**PARK CITY PLANNING COMMISSION MEETING
SUMMIT COUNTY, UTAH
June 25, 2025**

Planning Commission Staff Report

Subject: 301 Marsac Avenue
Applications: Plat Amendment: PL-23-05946
Steep Slope CUP: PL-23-05946
Author: Elissa Martin, Planning Project Manager
Date: June 25, 2025
Type of Item: Work Session

Figure 10: 301 Marsac Ave proposed SFD building footprint

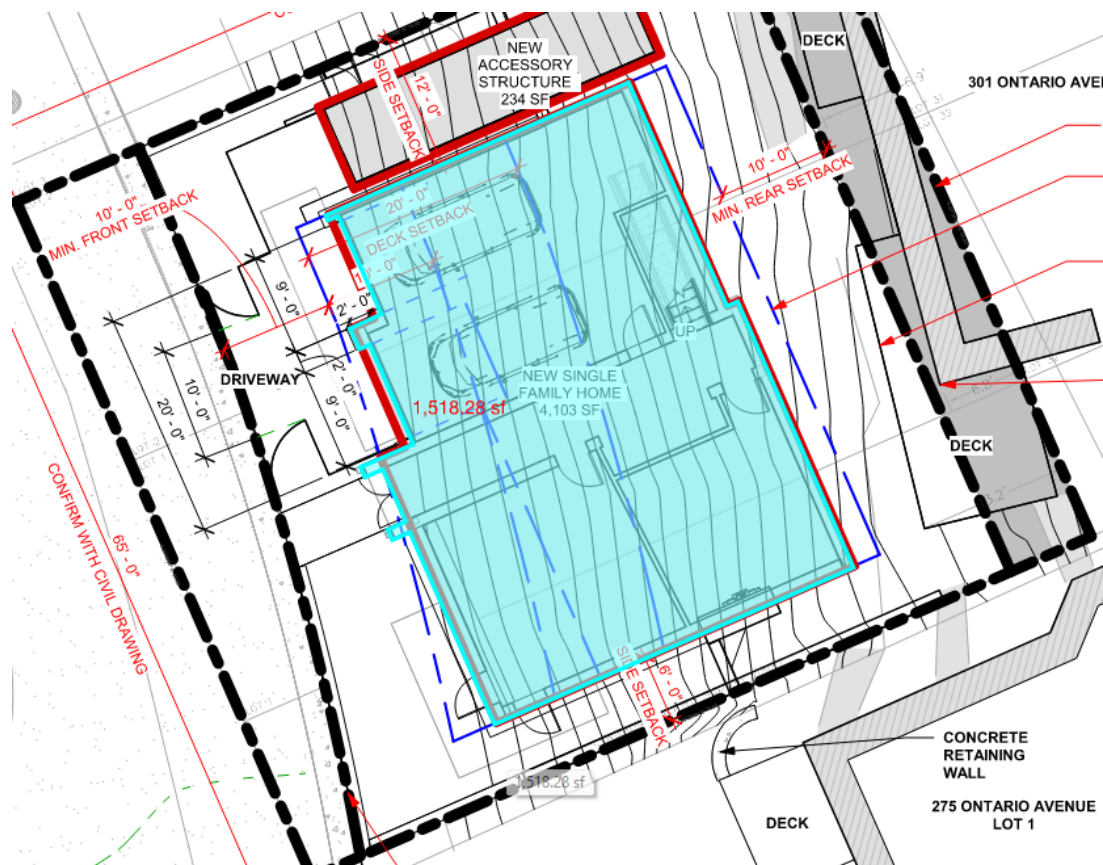
DOES NOT COMPLY: According to the Applicant's plans and staff's measurements, the total Area of the foundation for the proposed SFD is 1,518 square feet. However, the Accessory Building adds an additional 234 square feet to the footprint.

The Applicant must modify the plans to either reduce the Building Footprint of the SFD or remove the Accessory Building.

Figure 12: Applicant's submitted plans showing the distance from the lowest finish floor plane to the point of the highest wall top plate

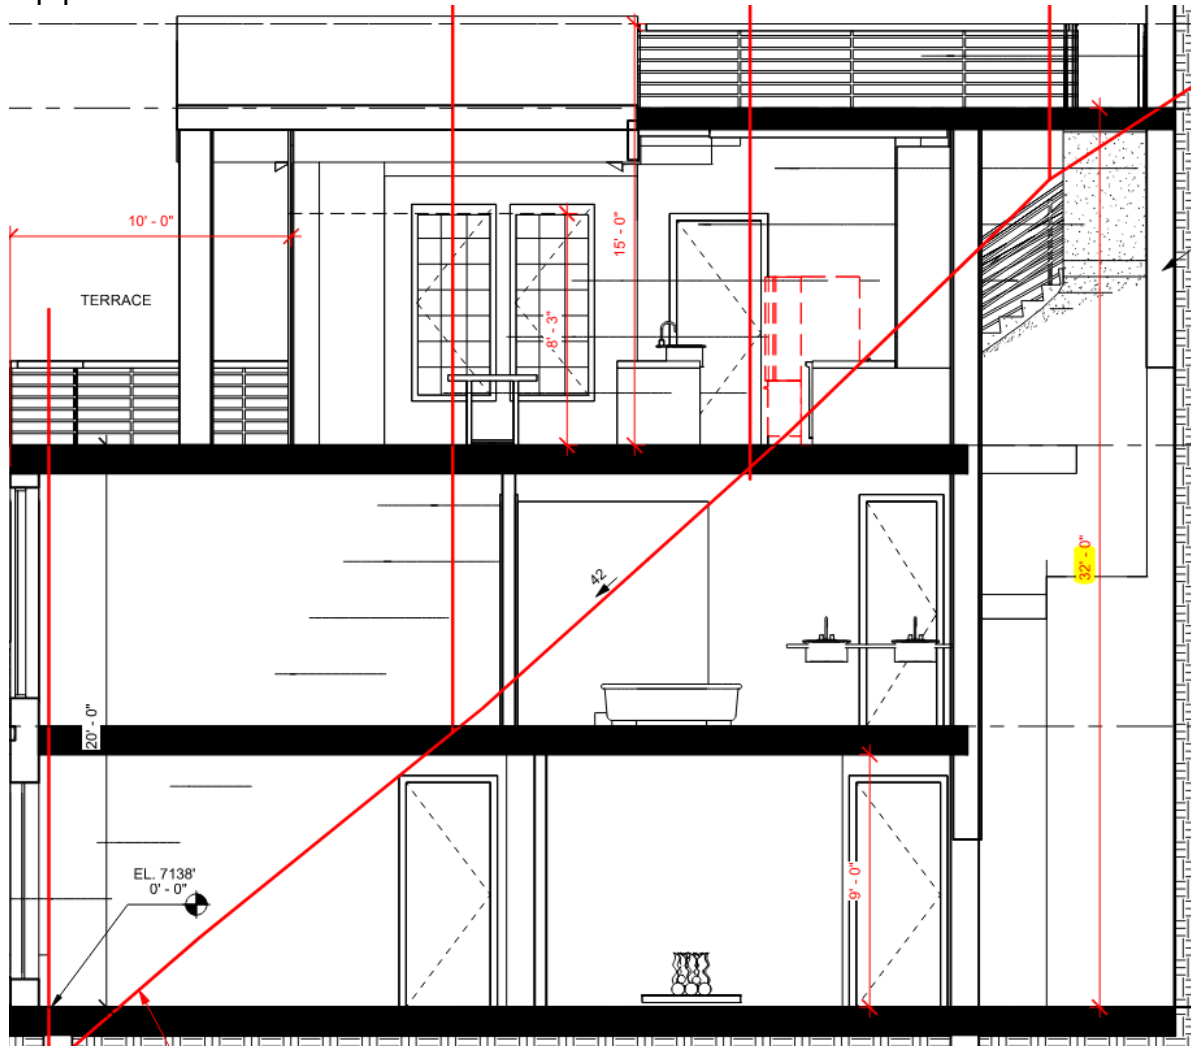
COMPLIES: According to the Applicant's submitted plans, the proposed SFD has an interior height of 32 feet measured from the ground level floor plane to the highest wall top plate.

Figure 13: Sheet A2.4 with staff's measurements showing the 10-foot step back in the downhill facade

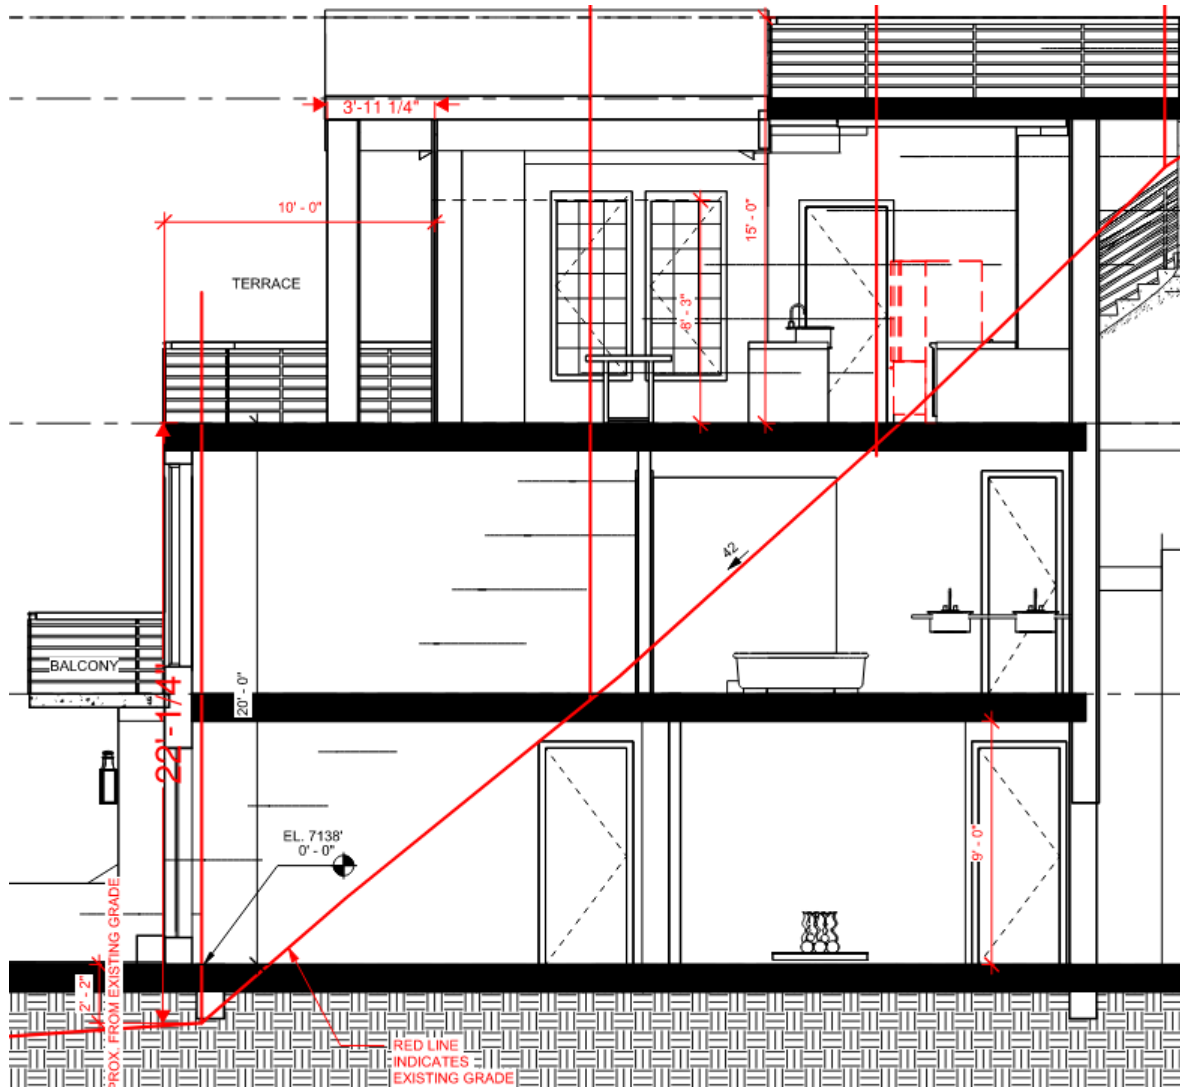
PARTIALLY COMPLIES: The Applicant's plans show the front façade rises approximately 22 feet from lowest point of Existing Grade at which point there is a 10-foot step back provided by the second level deck.

The roof overhang may be considered an 'architectural feature' that provides articulation to the upper story façade, which may encroach into the minimum 10-foot step back, but shall be limited to no more than 25% of the width of the building and shall encroach no more than four feet into the step back.¹⁰ As proposed, the roof overhang encroaches no more than four feet into the 10-foot step back. However, the width of the overhang is 13.75 feet and the width of the building is 46.5 feet. The roof overhang is 29.5% of the width of the building, which does not comply.

The plans must be modified to reduce the width of the roof overhang to meet the Building Height stepback standard, which requires the architectural features that encroach into the 10-foot step back to be no more than 25% of the width of the building.

Figure 14: Applicant's plans showing the Roof Forms measured from the primary facade to the rear of the building.

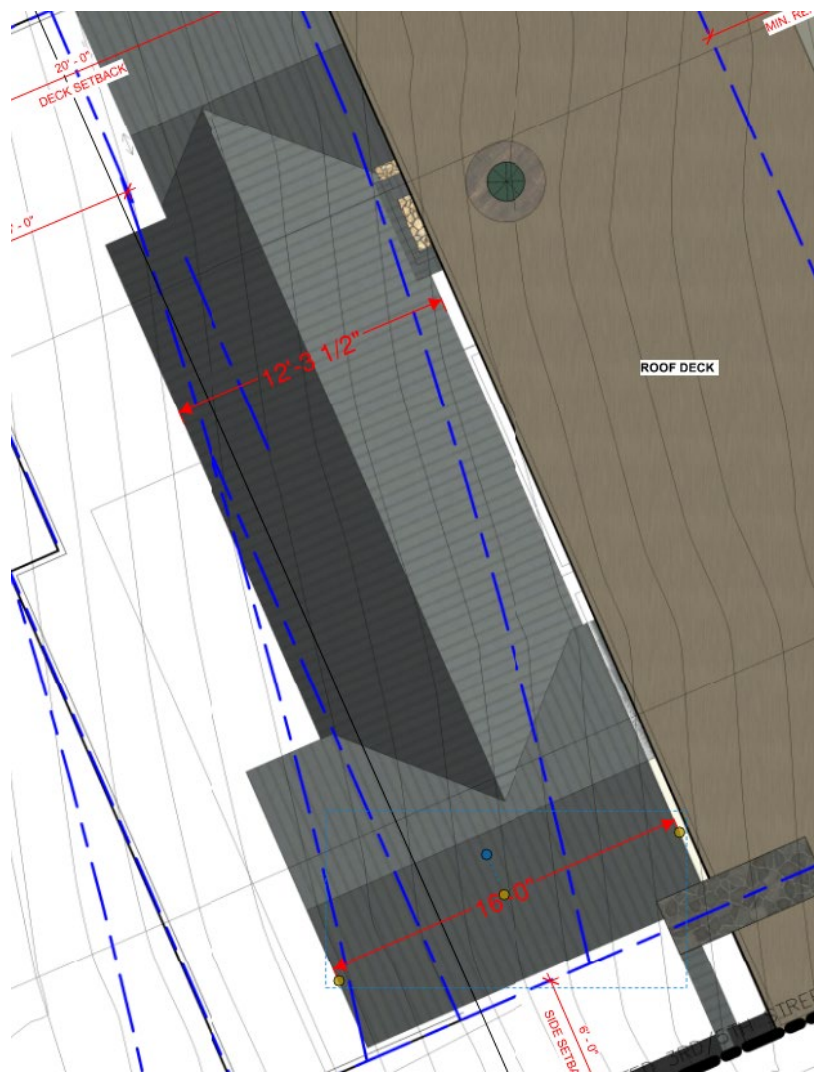
PARTIALLY COMPLIES: The Applicant's plans show the roof pitch of the Contributing Roof Form has a compliant 7:12 roof pitch. However, the Contributing Roof Form does not occupy a minimum horizontal distance of 20 feet measured from the primary façade to the rear of the building.

The plans must be modified to extend the depth of the Contributing Roof Form to occupy a minimum horizontal distance of 20 feet.

Figure 16: proposed two-car garage with two-foot offset between garages

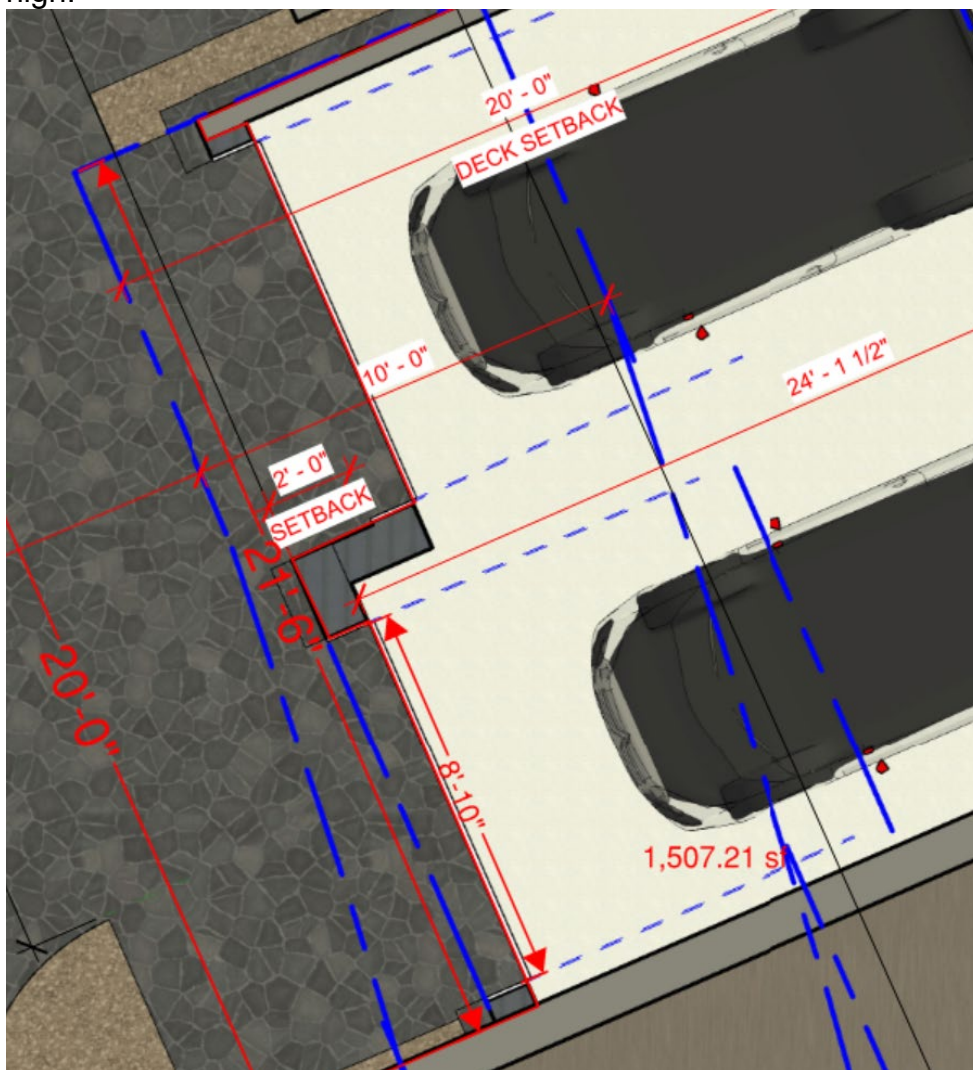
COMPLIES: The Applicant's plans show the 2-foot horizontal offset in the front wall plane between the two garage doors, and the garage doors are 9 feet wide by 9 feet high.

Figure 17: Topographic Map showing Slopes between 90%-100%.

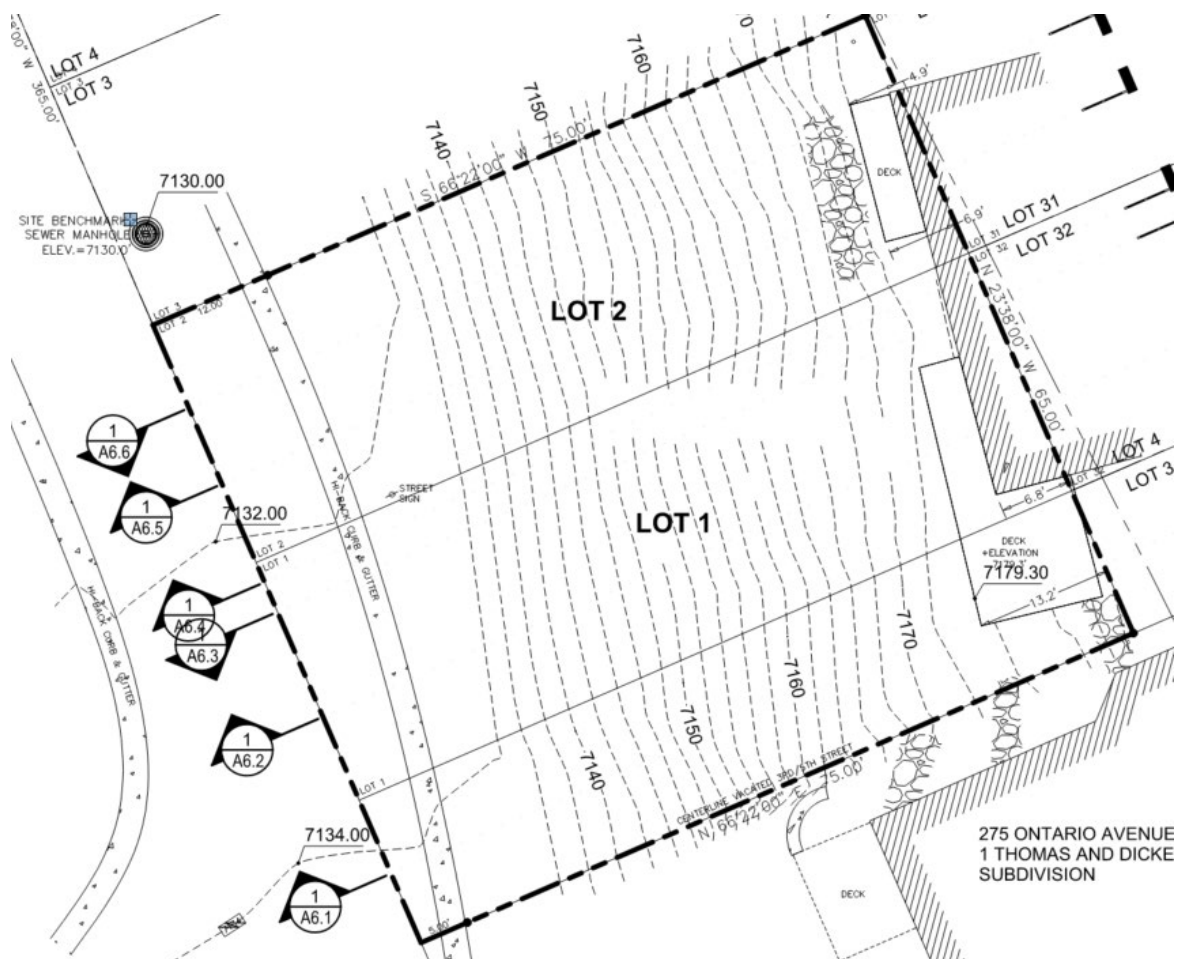
The Applicant submitted a topographic map that indicates the majority of the Parcel proposed for development consists of Very Steep Slopes, which the LMC defines as Slopes greater than 40%.¹² The Slopes at 301 Marsac range between 90% - 100%. The Very Steep Slopes together with minimal Lot depth, significantly constrain development on the site. The proposed plans illustrate the large area required to be excavated and the use of retaining walls on the rear and sides of the Structure.

Figure 23: View from the south

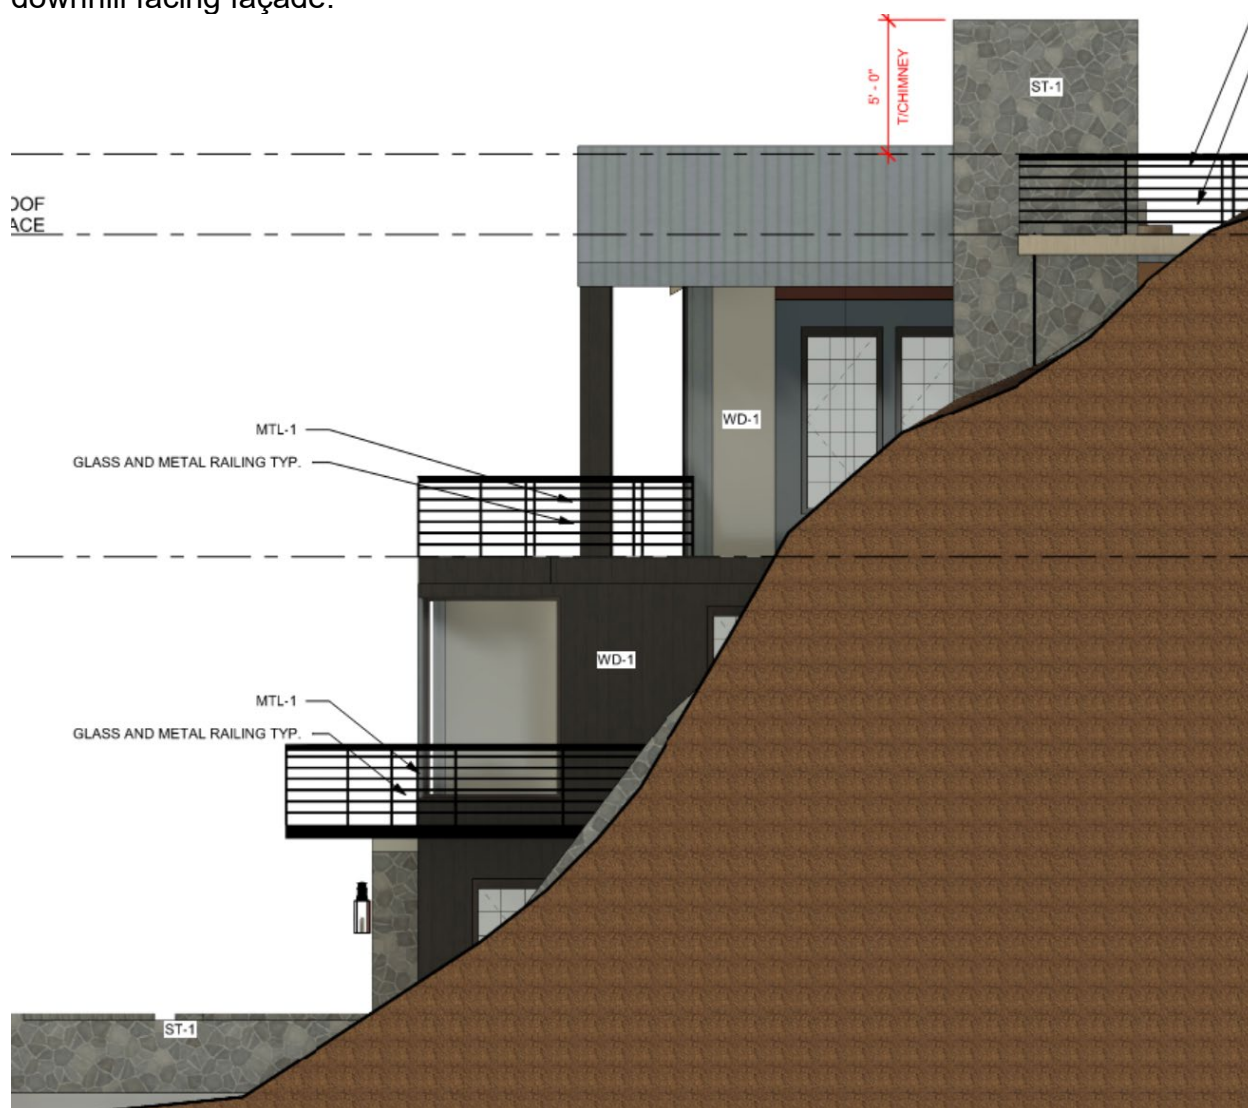
The proposed SFD partially complies with the above requirement by orienting against the Lot's contours and stepping with grade with a ten-foot horizontal step back on the downhill facing façade.
